MEMORANDUM

RE: 11 Lyman Place

Ricardo Dos Anjos, 11 Lyman Place LLC, (the “Applicant” and “Owner”) is seeking Site Plan and Subdivision approval to construction two new one-family dwellings while subdividing the existing lot into two lots, labeled Lot No. 1 and Lot No. 2. The property is located at 11 Lyman Place, Section Block and Lot 3.60-22-3 (“Project Site”) and is located in the OF-6, One Family Residential 6, zoning district.

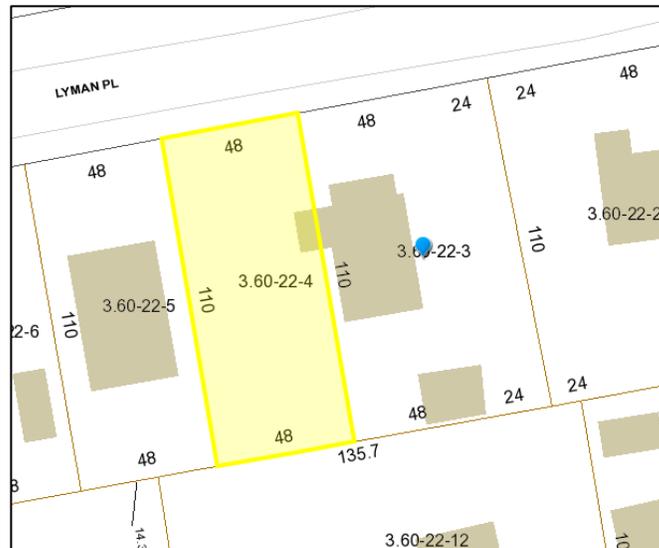
1. **SEQR.**
 - a. This application is categorized as an Unlisted action under SEQR because it consists of a minor subdivision. The Planning Board should indicate their intent to be Lead Agency for the Project.
 - b. The Applicant has provided a Short Environmental Assessment Form Part 1, for which we have no comments to offer.
2. **Site Plan Approval.** This application requires Site Plan approval by the Planning Board per Section 300-52 of the Zoning chapter. A public hearing will be required for Site Plan approval.
3. **Subdivision.** The Applicant has asserted the application involves the subdivision of the existing lot at SBL 3.60-22-3. It appears that the application is instead a lot line adjustment between lots 3.60-22-3 and 3.60-22-4, which is still considered a subdivision according to §300-14 of the Village Code. According to the Town of Greenburgh property data card, these

two lots are separate lots. The Applicant should provide additional information related to the two lots, as it appears these are already two separate tax lots. See image below.
